| Settlement | Mosstodloch |
| Site Address | Land to the far east of Stynie Road (Parcel 3, Phase 1) |
| Ref Number | R6A |
| Bid Summary | Residential development (120 houses) |

| Ref Number | SITE 3, SITE 4, SITE 5 |

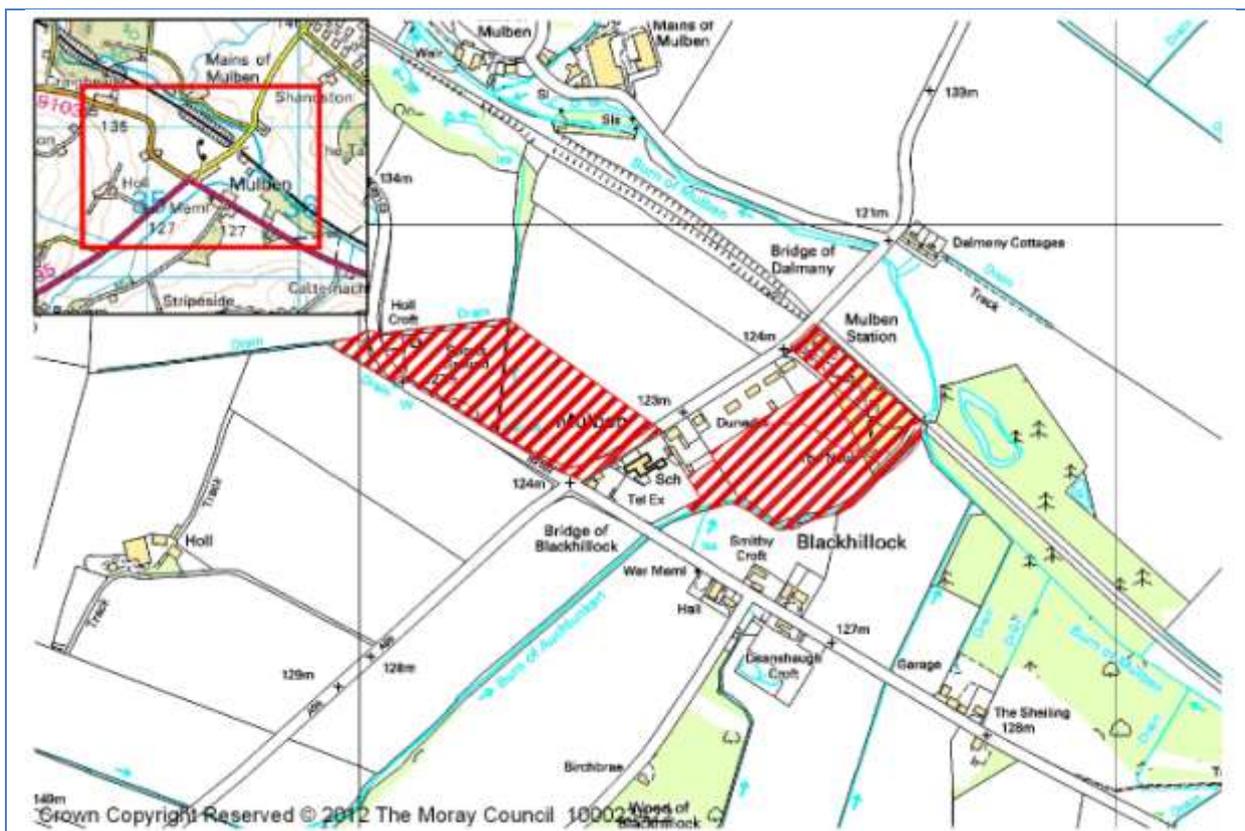
| Transportation | Transportation section comments awaited. Neither of the two sites put forward are seeking access onto the A95. |

| <p>Flooding</p> | <p>Site adjacent to Mulben Station -The FRA has already been carried out and approved by us. Removed a previous objection to the site in 2008 Local Plan. Note this is not the same site as was put forward in the 2008 Plan and therefore there are still unresolved issues relating to flooding albeit these could be resolved in a similar manner to planning application 06/01594/FUL. Flood Team – Although site 1 is shown as outside the flood risk envelope as shown on SEPA's indicative flood risk map a Flood Risk Assessment is required, the proposal states that a Flood Risk Assessment has been carried out this should be reviewed prior to this land being allocated for housing. Site 2 - There is no known fluvial flooding at this location.</p> |
| <p>Landscape</p> | <p>The crossroads at Mulben is relatively flat and therefore the development of site 1 and 2 should not be a prominent feature in the landscape. Site 1 at the Neuk is relatively visually contained by it siting within the main body of Mulben to the rear of the newer housing development on site A. Site 2 is detached from the existing hamlet by means of the public road and introduces development where currently there is none. In this case landscaping would be required to soften the developments</p> |

| Biodiversity/Natura | River Spey SAC – the development is within the catchment of the Burn of Mulben, a tributary of the River Spey. The lower reaches of the burn are included within the SAC. Sufficient information will be required at the application stage to confirm that adequate protection measures are able to be implemented to protect the water environment. Potential to include housing and surface design ideas to reduce surface water run off. Optimise the extent of green areas that can absorb rainwater. Potential to introduce native tree planting to enhance residential area and encourage birdlife. Deterioration of the Mulben Burn should be prevented. |
| Water/Waste water | SEPA –No public sewers in the area. Effluent disposal from multi-house developments will require investigative work. Scottish Water – water supply Badentinan indicative supply 74 units. Waste water treatment works – private. |
| Overall Planning Assessment | Site B has planning consent (06/01594/FUL) for the construction of 12 dwellings. This allocation is considered adequate to meet local demand in the currency of the next local plan. In addition to this, if required there may be the opportunity for further development in the substantial area of white land adjacent site B that is not required for servicing and infrastructure. This will be subject to gaining safe and suitable access onto the A95 which may require upgrading of the access approved under the terms of 06/01594/FUL to accommodate an increased level of development. It is not considered there is sufficient justification for the allocation of additional land in Mulben or extending the rural community boundary. |
